**Planning & Zoning Commission
Tuesday, July 5, 2022, 6:00 PM
Public Meeting Room / Eagle Town Hall
200 Broadway, Eagle, CO 81631**

1. Project: 435 Eby Creek Apartments Major Development Permit
File #: DR22-03
Applicant: Jeffrey P Manley AIA, Martin Manley Architects
Location: 435 Eby Creek Road
Staff Contact: Peyton Heitzman, Planner II
Request: Seeking approval for a Major Development Permit to construct a 30-dwelling unit apartment building on 2.804 acres.

435 EBY CREEK ROAD
Subdivision: PERRY SUBDIVISION Lot: 3, PHASE II
UPDATED DEVELOPMENT PERMIT SET

SHEET NO.
C5.0

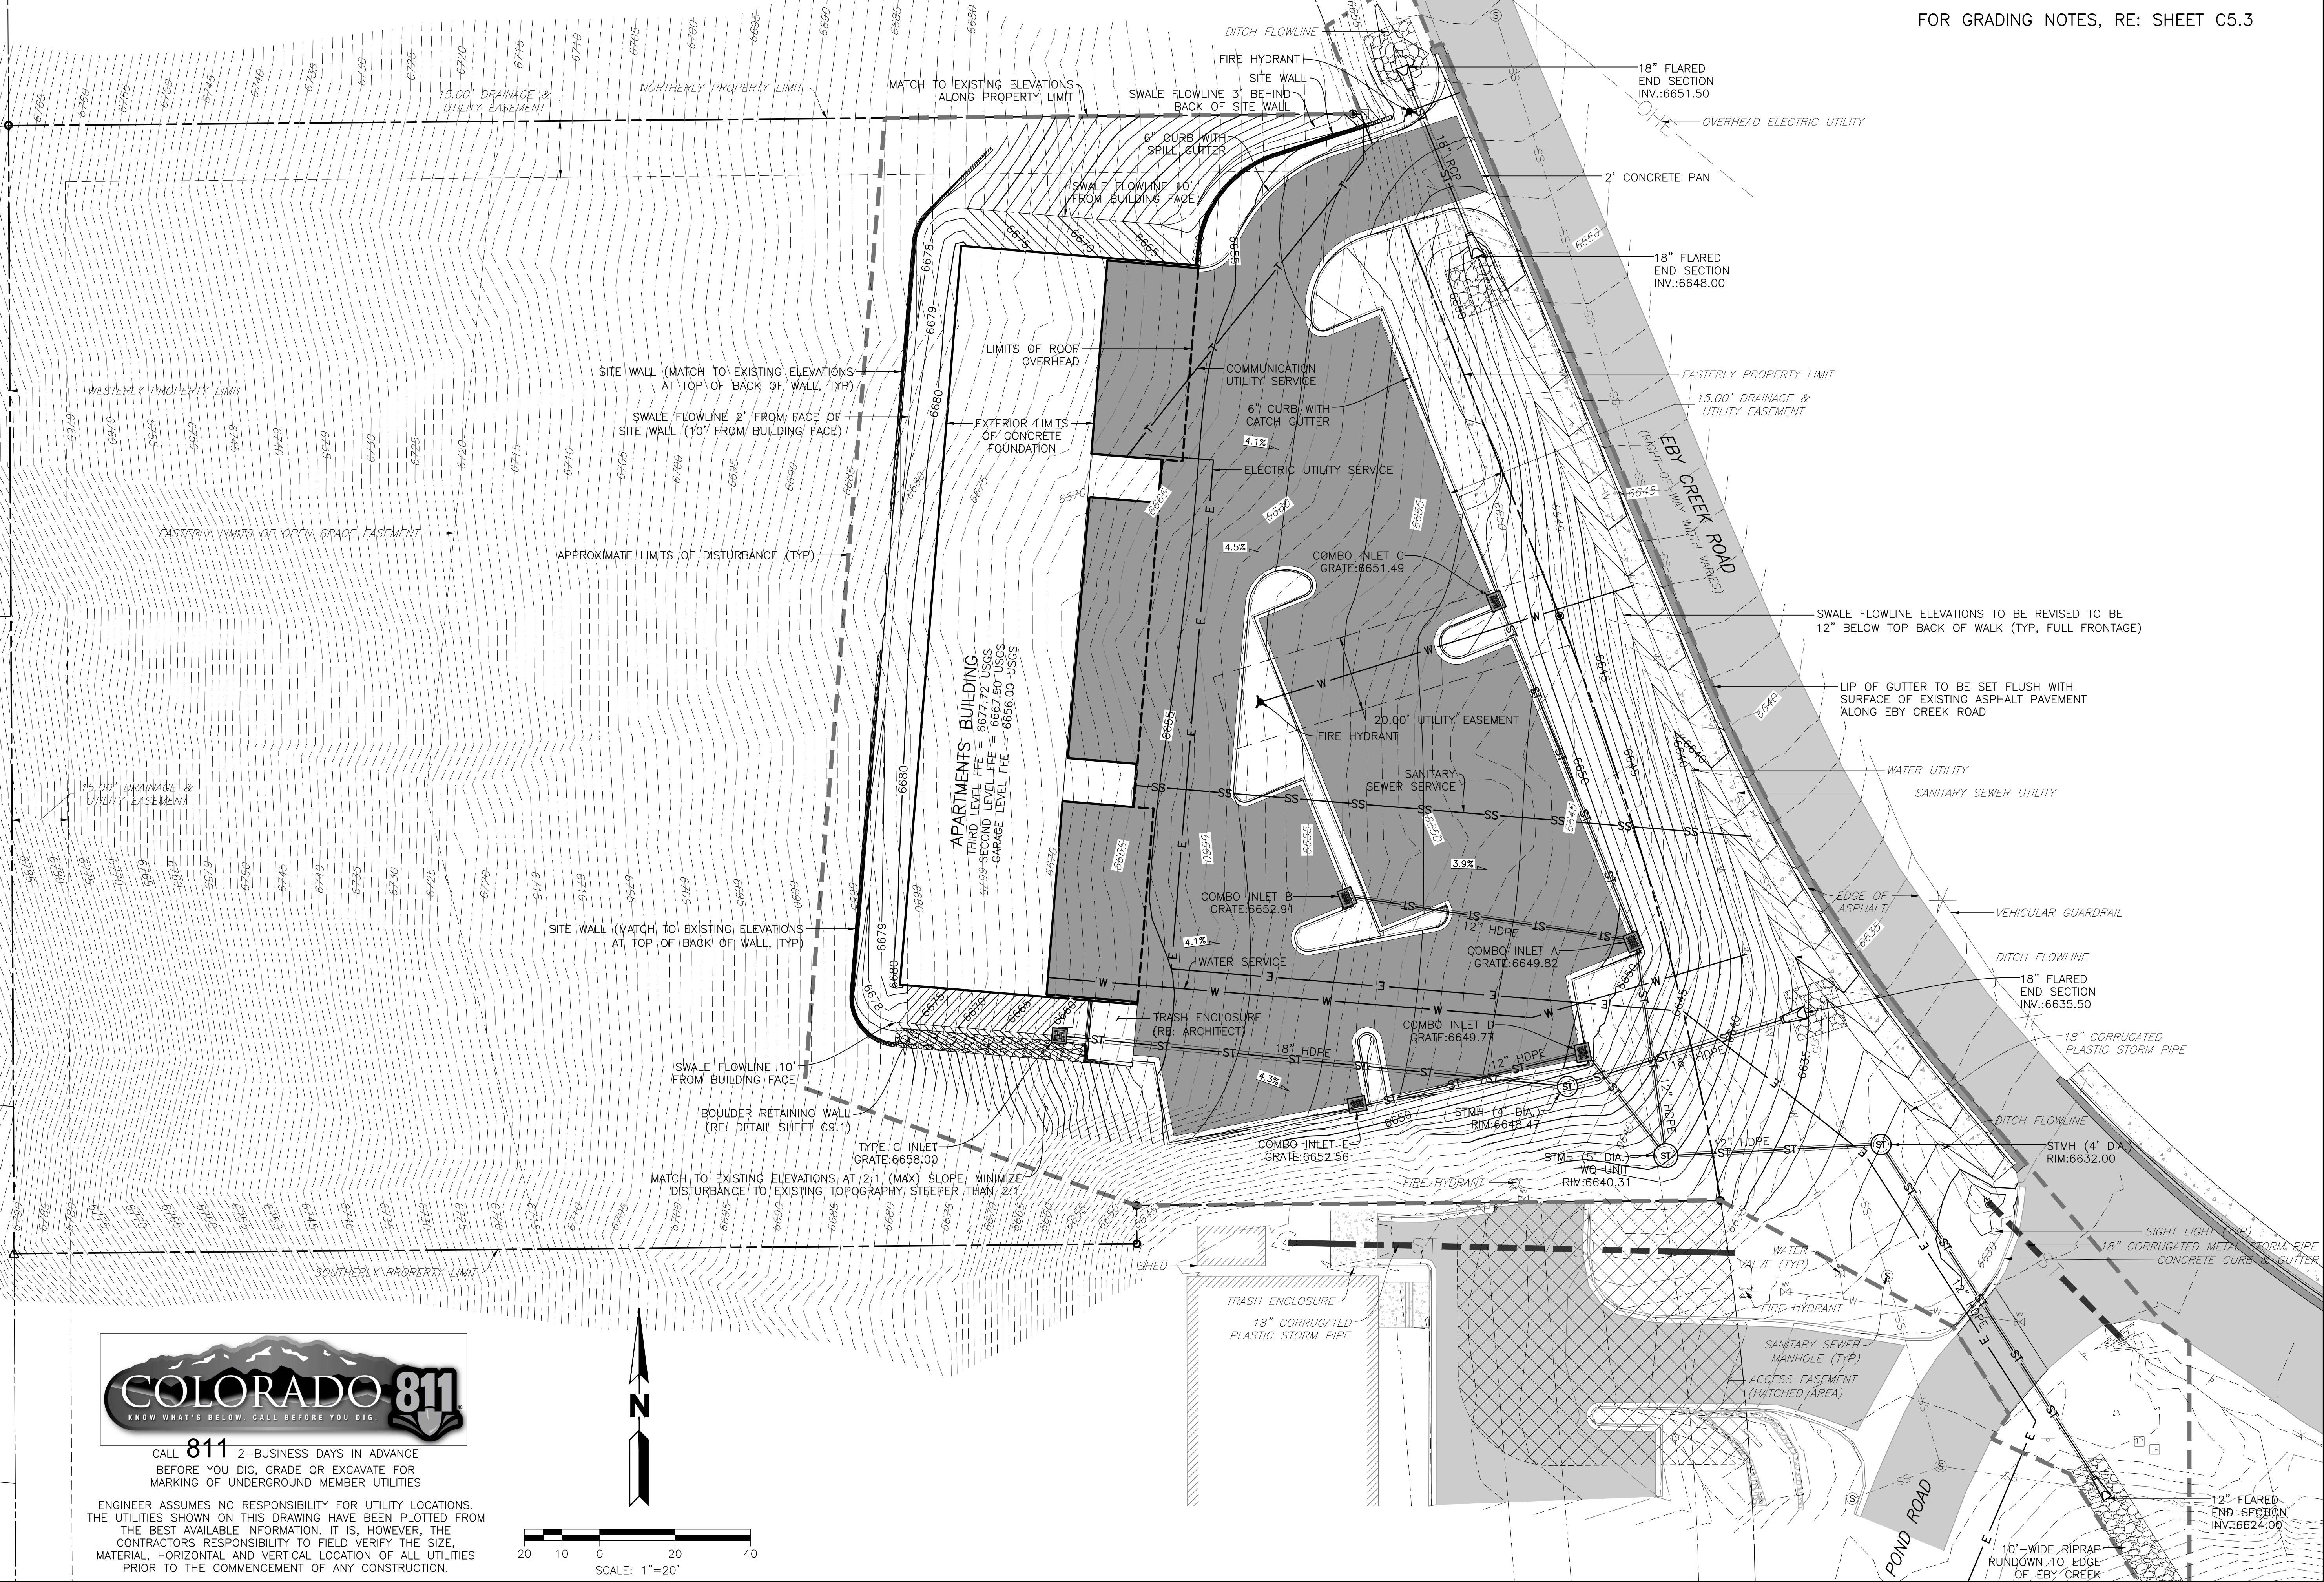
Applicant Response: Developer and Architect have met with GEFPD Fire Marshall (Randy Cohen) to evaluate the site design, building design, and site fire hydrant layouts. The Civil Plan sheet C5.0 illustrates the addition of (2) fire hydrants to the property. These were added and located at the direction of Mr. Cohen.

SHEET NO.
C6.0

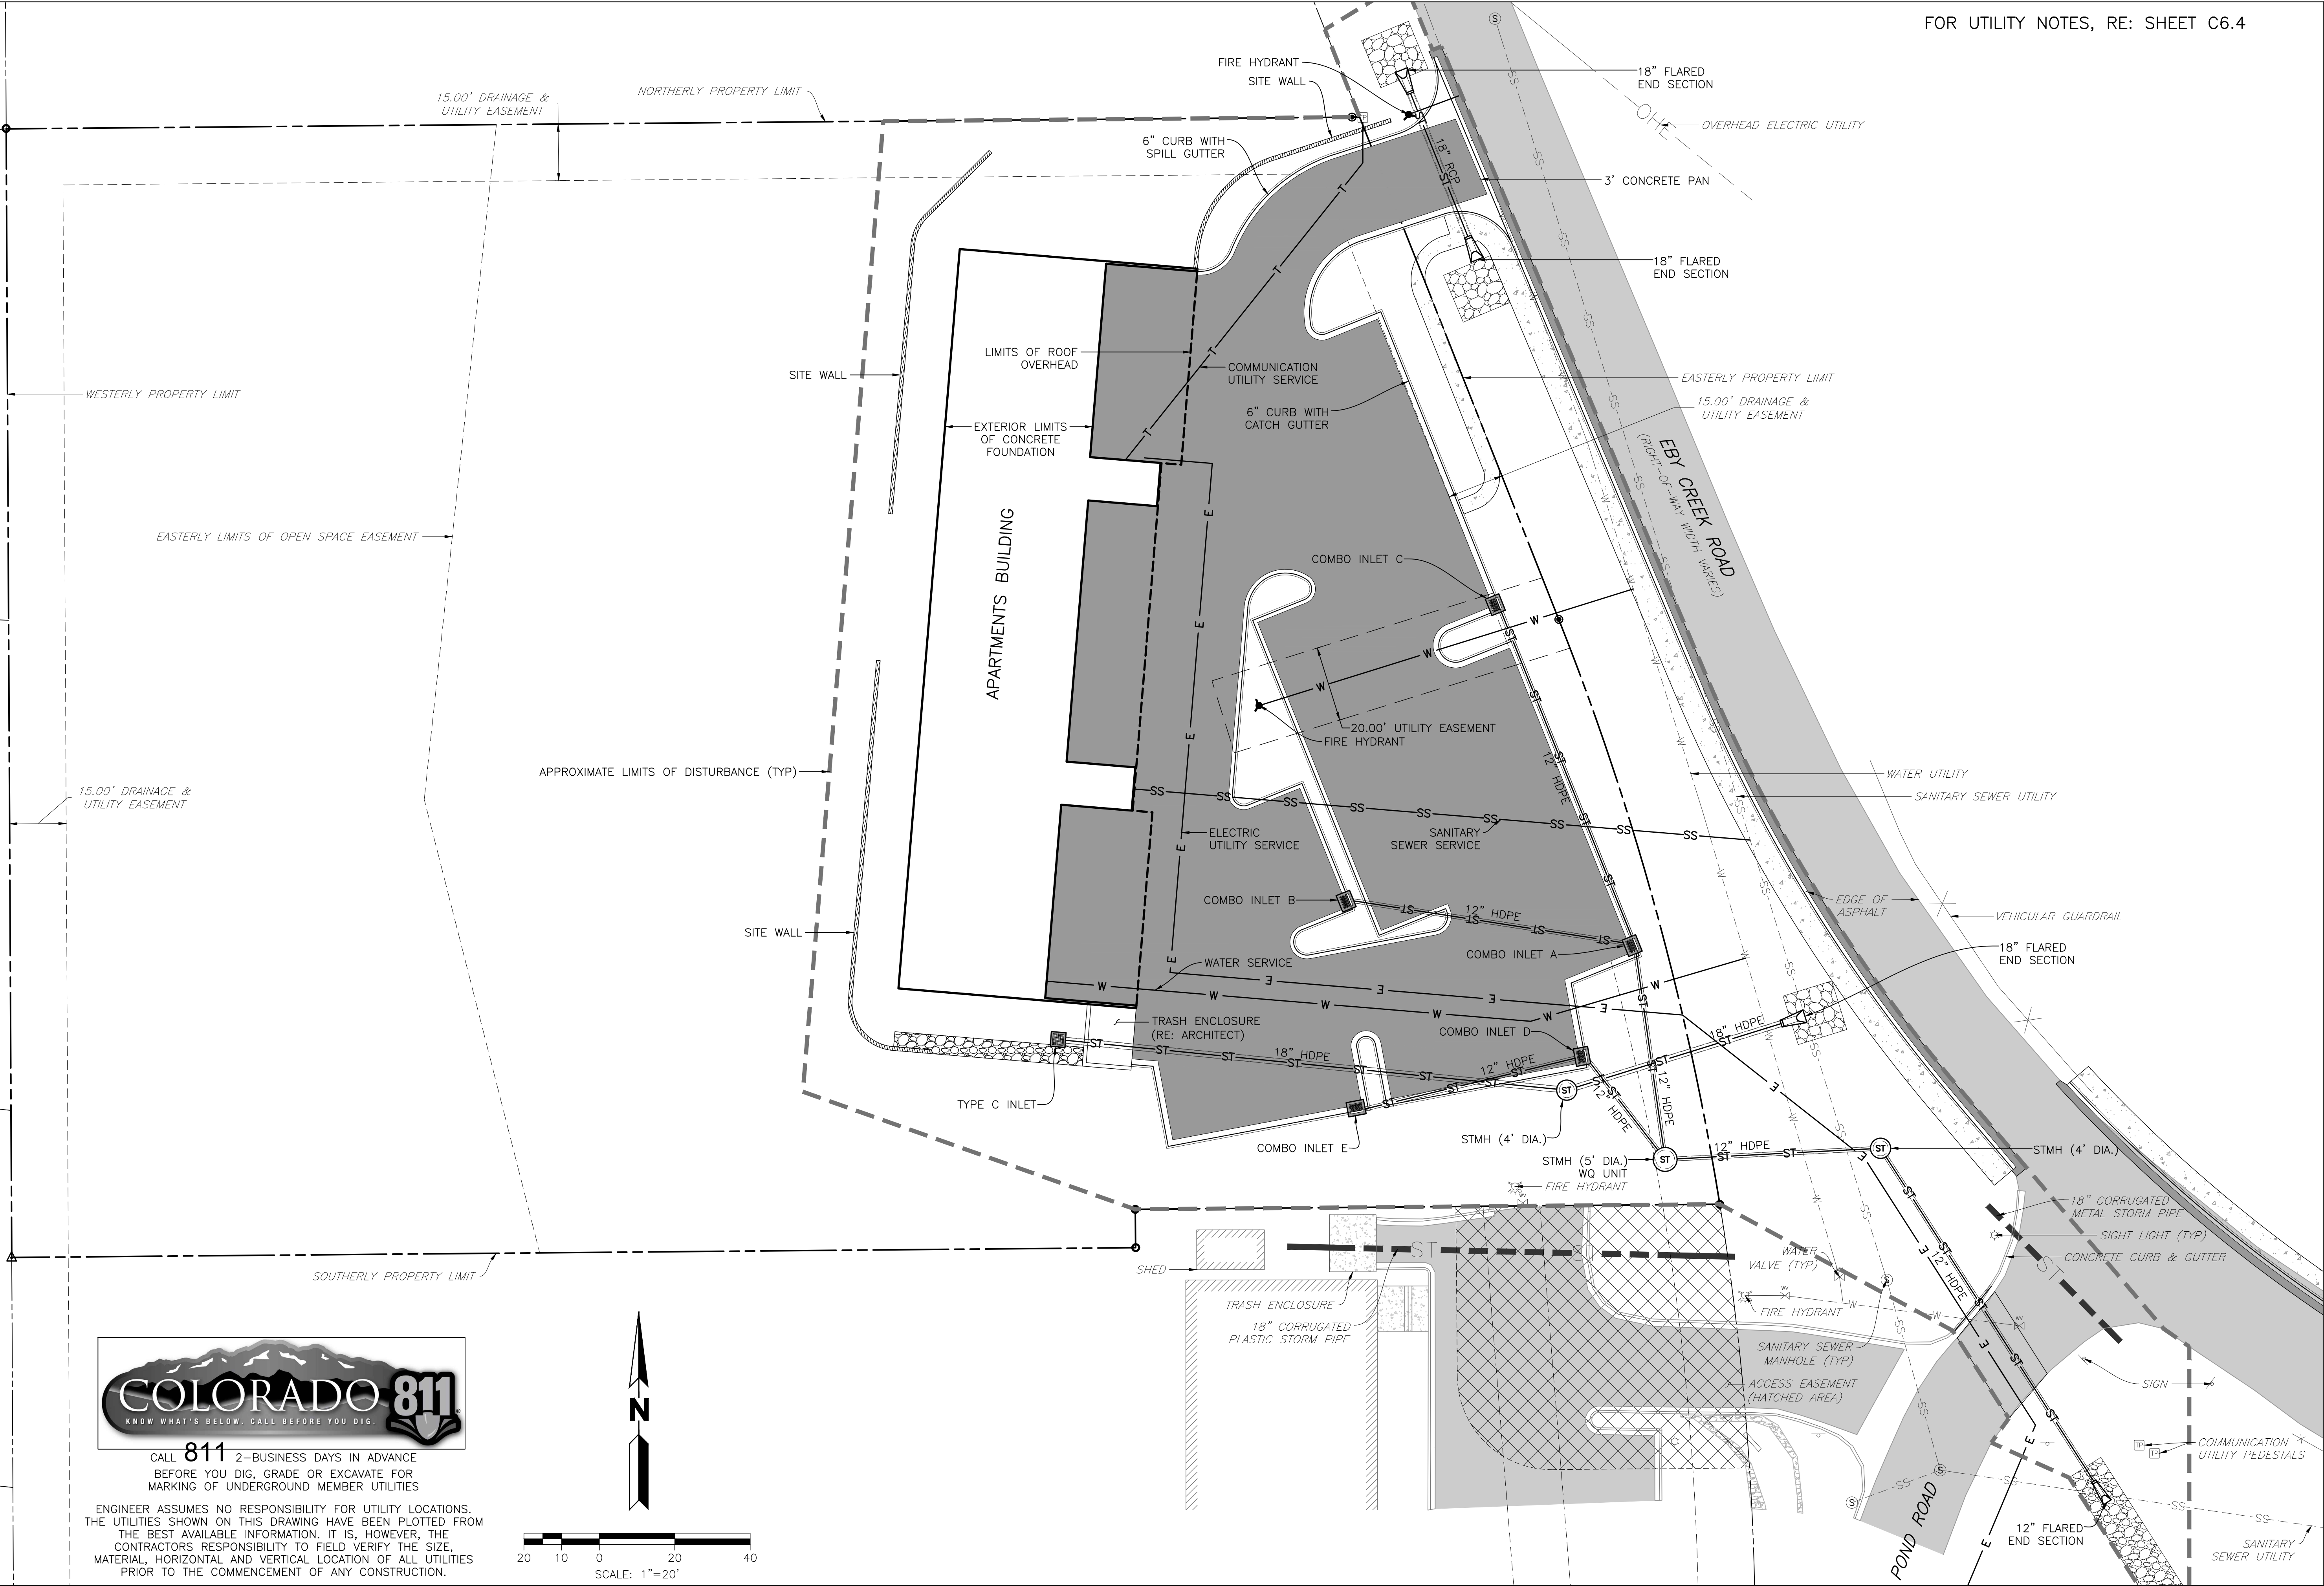
Staff Comment: The Utility Plan can be found on Sheet C6.0. Notes on Sheet C6.4 mention the installation of conduit for utilities. It appears that all service connection to the building will be underground; however, staff has included a condition of approval requiring that this standard be upheld.
